REQUEST FOR INFORMATION **DATE:** July 24, 2017 **NO.:** RFI-596

Project Name: 15051-Webster University Interdisciplinary Science Building Project No.: 15051

Subject: Light Conflict with Projector in Room 378

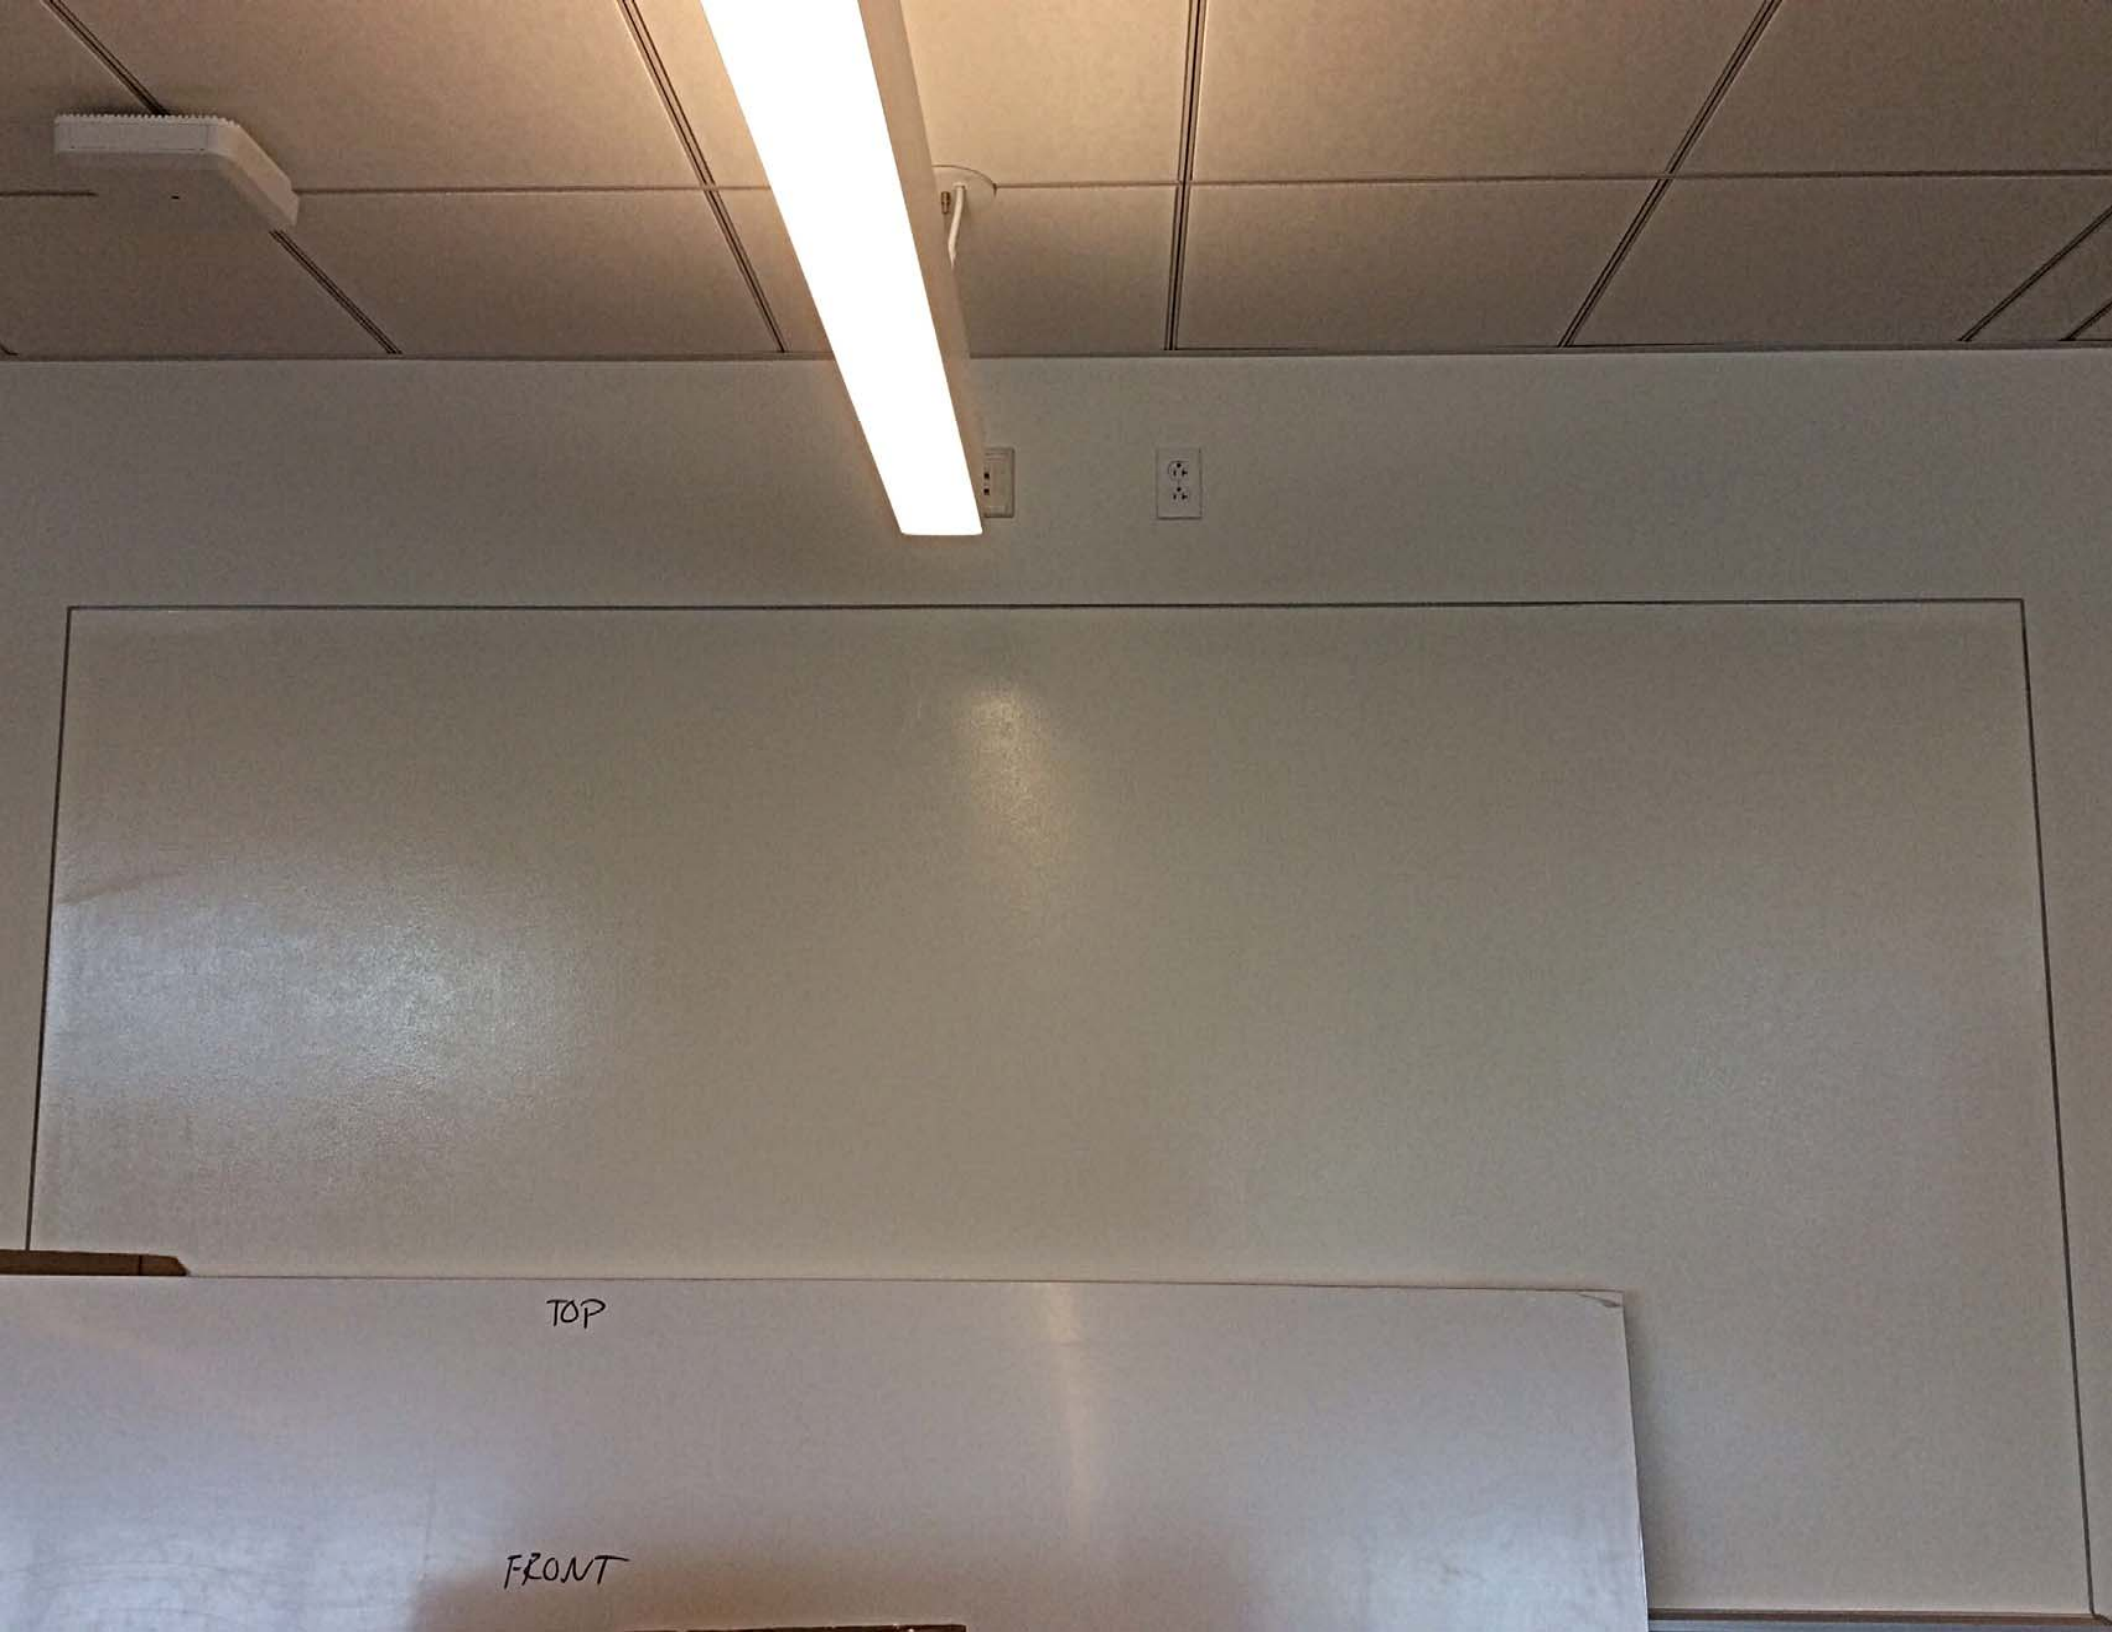
The Projector per T0103.A lines up exactly at the center of the pendant light. The Projector extends off the wall by 2'-4". The projector will extend into the location of the Pendant light. Please advise what are options will be.

Replace the 12' section of Type PA light fixture closest to the projector, with an 11' long section of Type PA from the stock of fixtures to be returned to the factory.
